RICHARD I. BONG MEMORIAL AIRPORT SUPERIOR, WISCONSIN A.I.P. 3-55-0083-07

RECORD DRAWINGS

WISCONSIN DEPARTMENT OF TRANSPORTATION BUREAU OF AERONAUTICS		CONSULTANT DESIGN:	CONSULTANT RECORD DRAWINGS:	RICHARD I. BONG MEMORIAL AIRPORT SUPERIOR, WISCONSIN
DESIGN PHASE		RECORD DRAWING		TITLE SHEET
APPROVED: _____ P.E. DATE: _____	APPROVED: <i>[Signature]</i> P.E. DATE: 10/10/05	APPROVED: <i>[Signature]</i> DATE: 10/6/05		A.I.P. 3-55-0083-07
APPROVED: _____ P.E. DATE: _____		APPROVED: _____ P.E. DATE: _____		DESIGN M.W.K. 05-'03 FILE NO. _____ DRAWN J.T.B. 05-'03 P.B. _____ CHECKED R.B.V. 05-'03 SCALE: AS NOTED
APPROVED: _____ P.E. DATE: _____		APPROVED: _____ P.E. DATE: _____		310 WEST SOUTH STREET, P.O. BOX 230 RICE LAKE, WISCONSIN 54008-0230 TELEPHONE (715) 234-7008 FAX (715) 234-1025
PROJECT NO. 00852093		SHEET 1		PROJECT NO. 00852093 SHEET 1

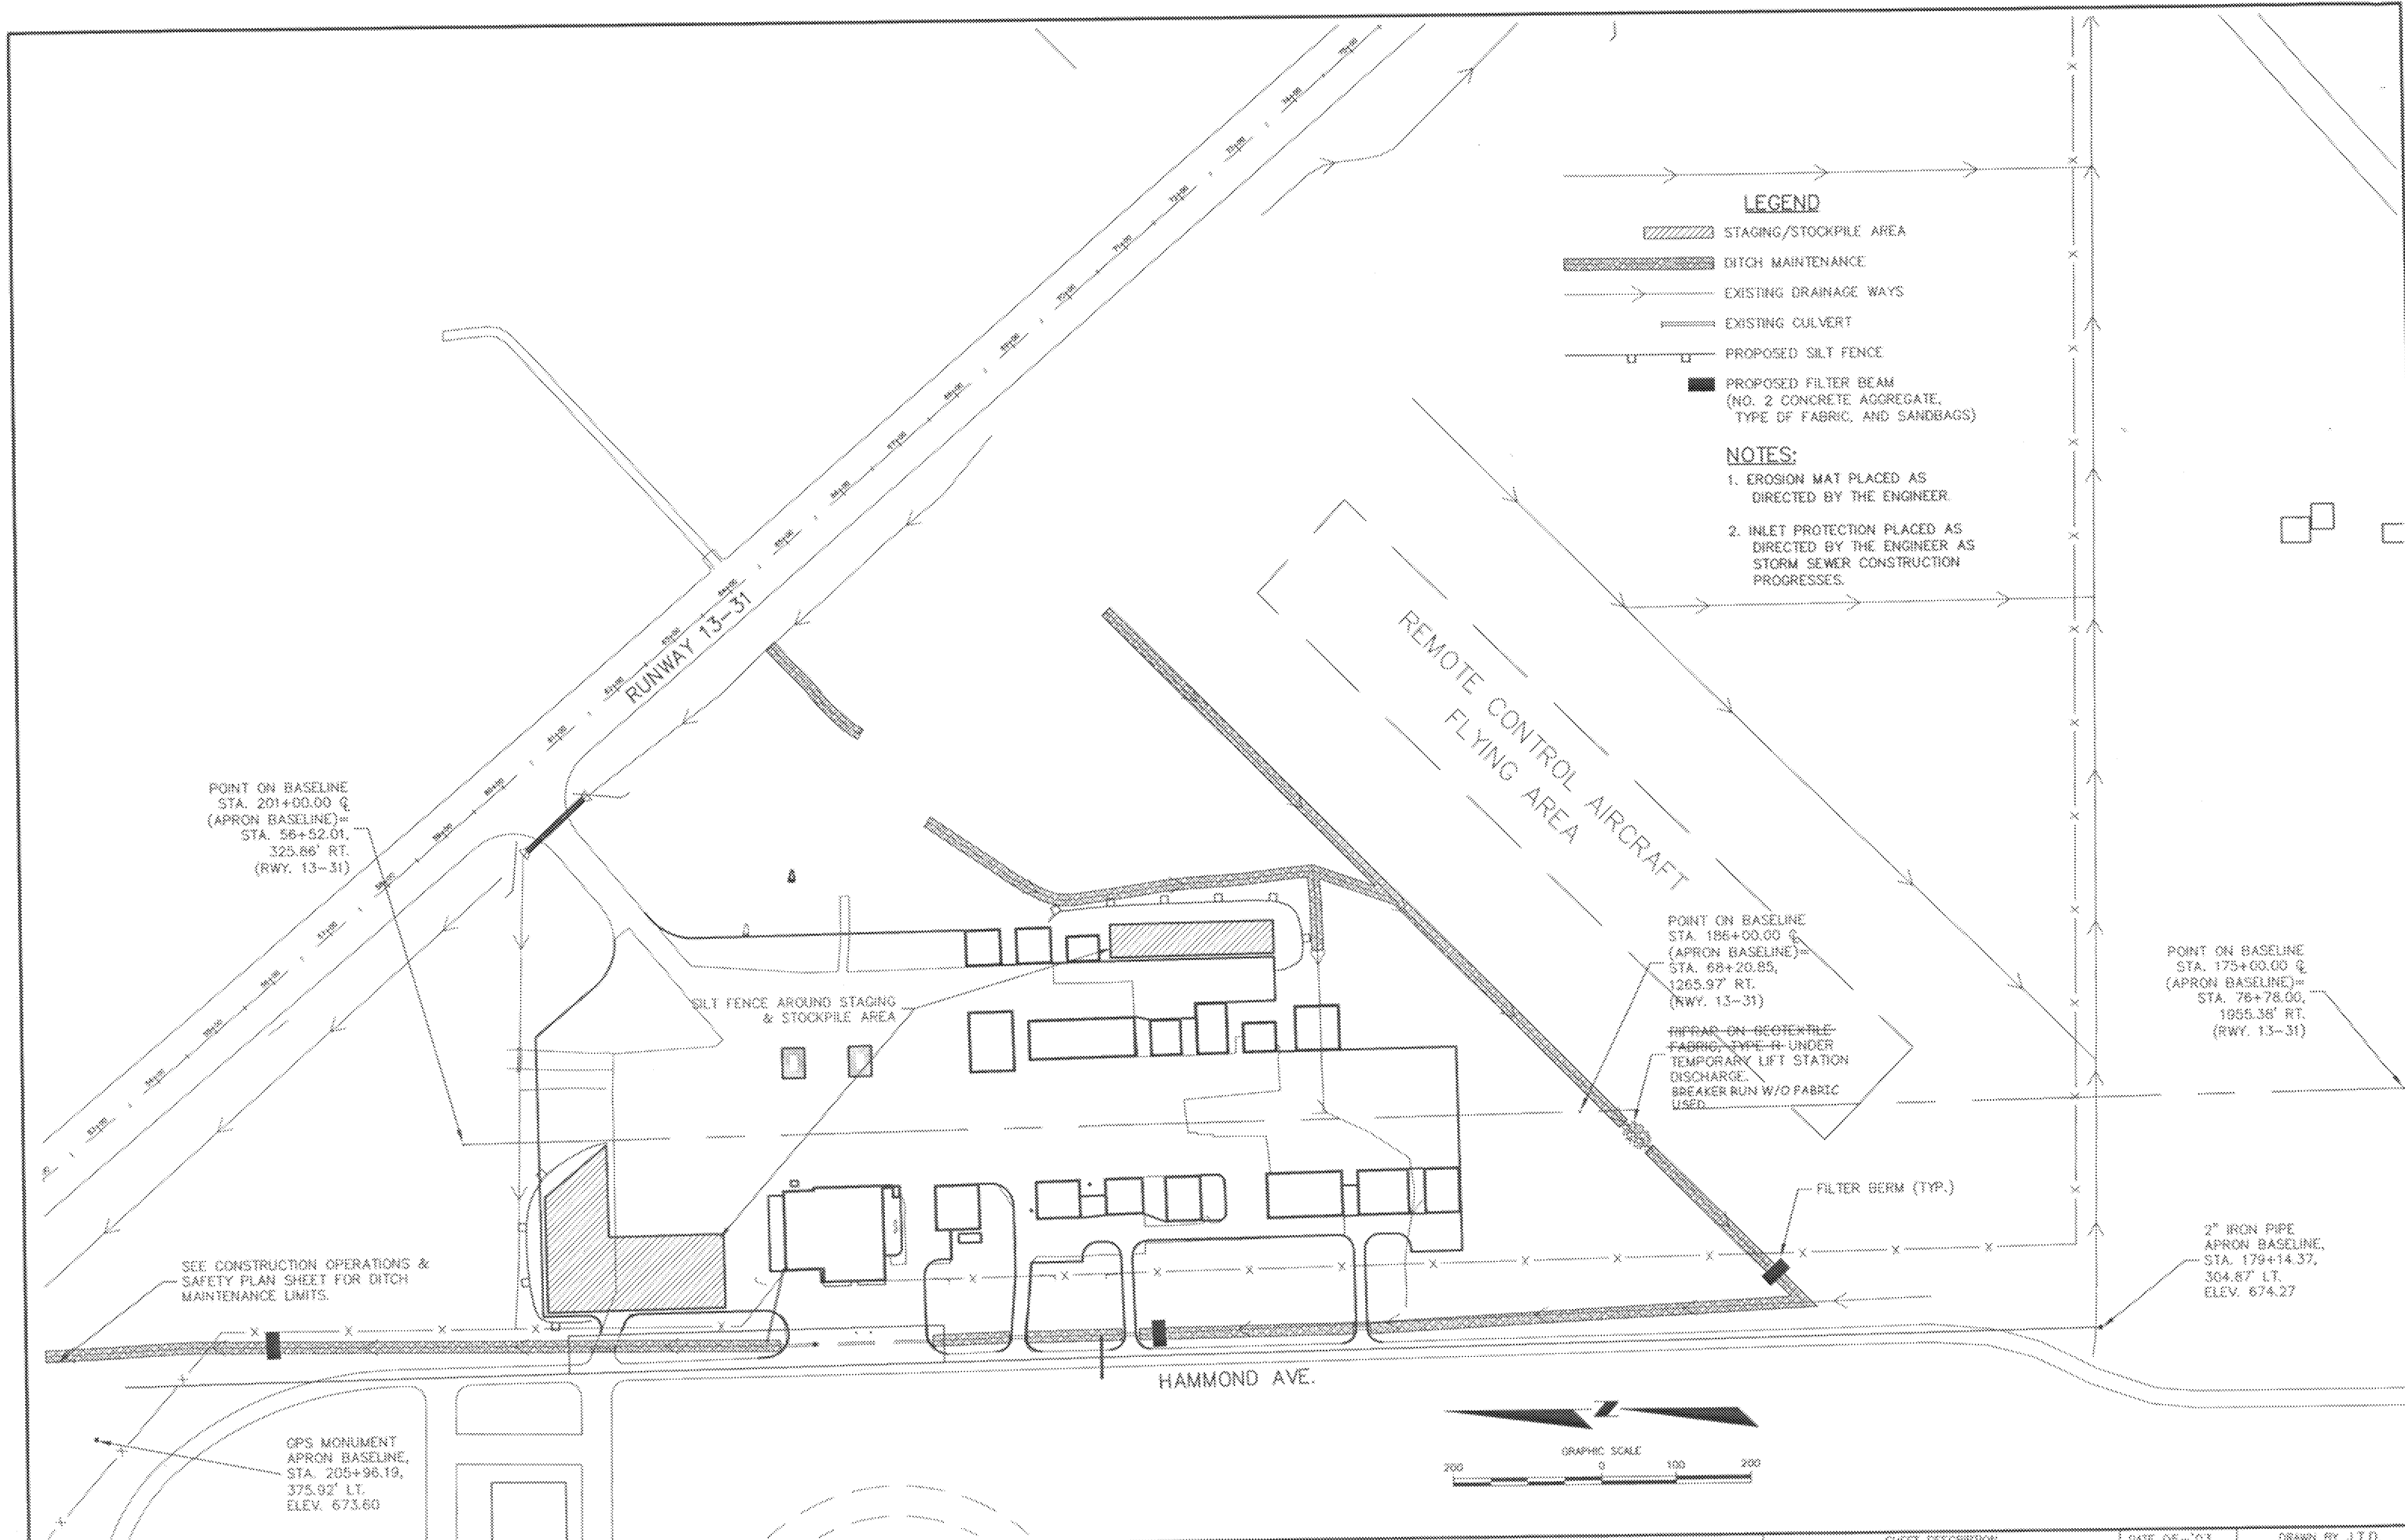
REPAIR ON GEOTEXTILE-
FABRIC TYPE-R UNDER
TEMPORARY LIFT STATION
DISCHARGE.
BREAKER RUN W/O FABRIC
USED.

SHEET 11 - REVISED

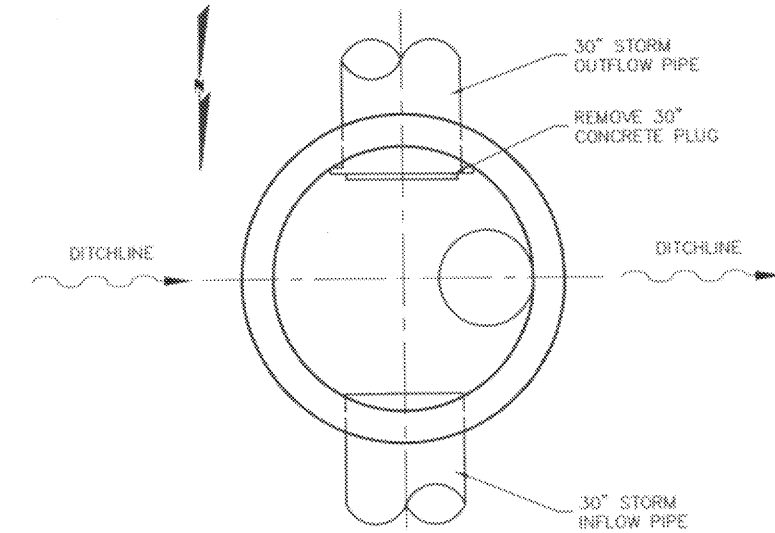
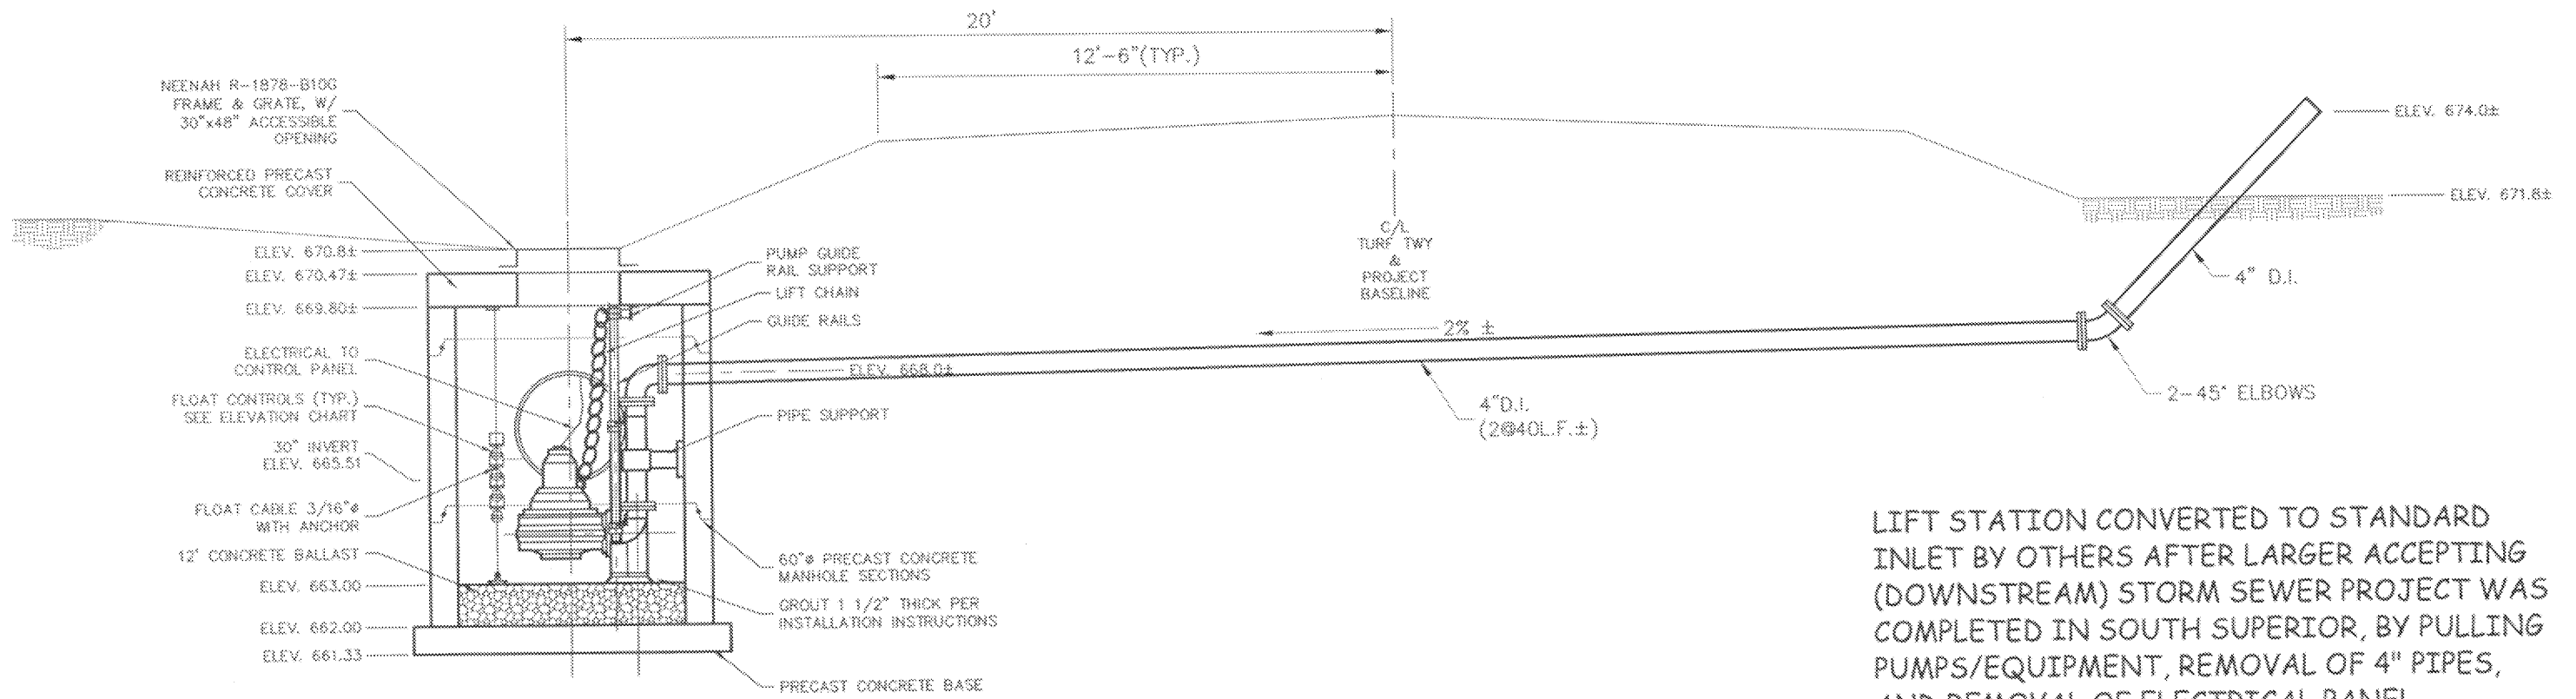
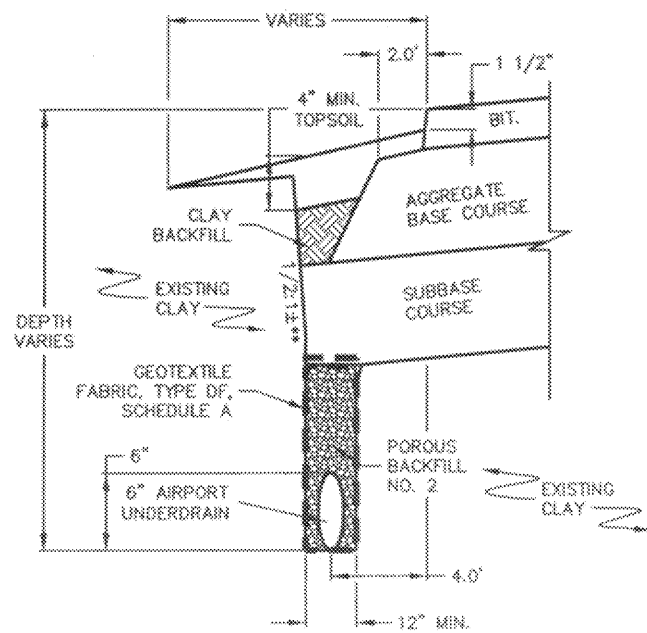
LIFT STATION CONVERTED TO STANDARD INLET BY OTHERS AFTER LARGER ACCEPTING (DOWNSTREAM) STORM SEWER PROJECT WAS COMPLETED IN SOUTH SUPERIOR, BY PULLING PUMPS/EQUIPMENT, REMOVAL OF 4" PIPES, AND REMOVAL OF ELECTRICAL PANEL.
